RS-01-092

Braidwood Station, Units 1 and 2
Facility Operating License Nos. NPF-72 and NPF-77
NRC Docket Nos. STN 50-456 and STN 50-457

Subject: Response to Request for Additional Information for Technical Specifications
Change to Revise Steam Generator Inspection Frequency for the Fall 2001
Refueling Outage for Braidwood Station, Unit 1

Response to Request for Additional Information for Technical Specifications Change to Revise Steam Generator Inspection Frequency for the Fall 2001 Refueling Outage for Braidwood Station, Unit 1

FIGURE A

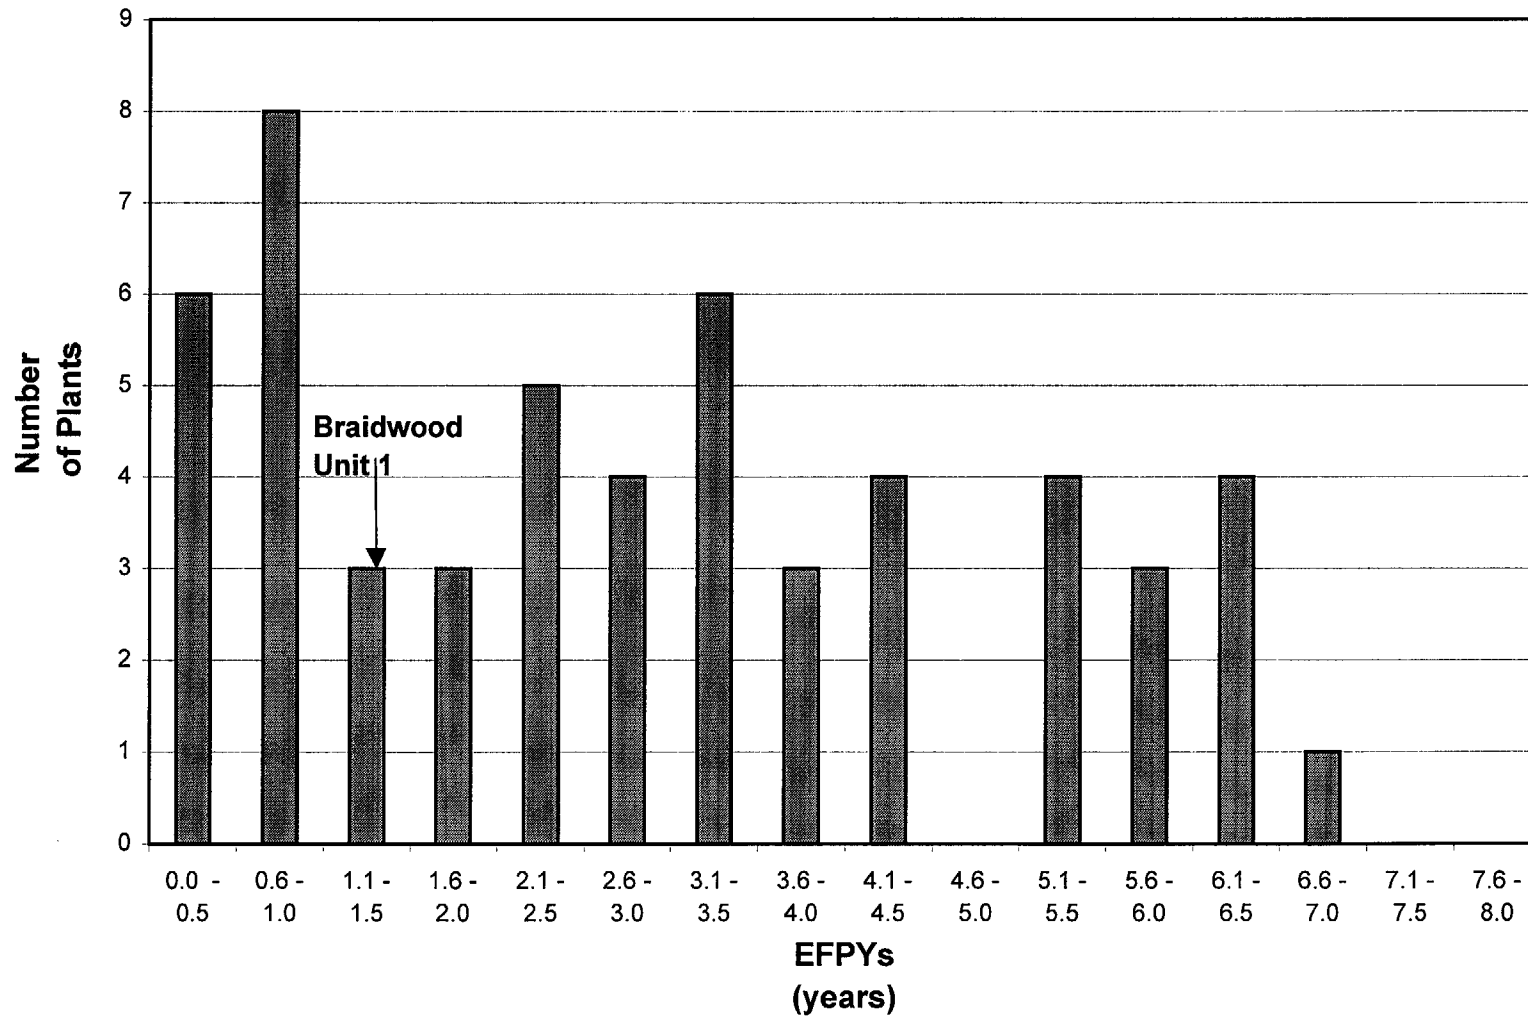
"On page 11 of Attachment A in the submittal, the licensee summarized industry experience of the RSGs with Alloy 690 tubing. Please briefly discuss the relevance of the experience in comparison of operating conditions, such as T_{hot} and water chemistry."

In a comparison of the Braidwood Station, Unit 1 RSG operating time in EFPYs to other units containing thermally treated Inconel-690 tubing, 38 of the 54 units have more operating time than Braidwood Station, Unit 1. To date, no units have reported any signs of degradation other than that associated with tube wear. This further supports our position that IGA and SCC will not develop early in the life of the SGs containing thermally treated Inconel-690 tubing and that SG inspections are not warranted during the upcoming Braidwood Station, Unit 1 fall 2001 refueling outage (see Figure A).
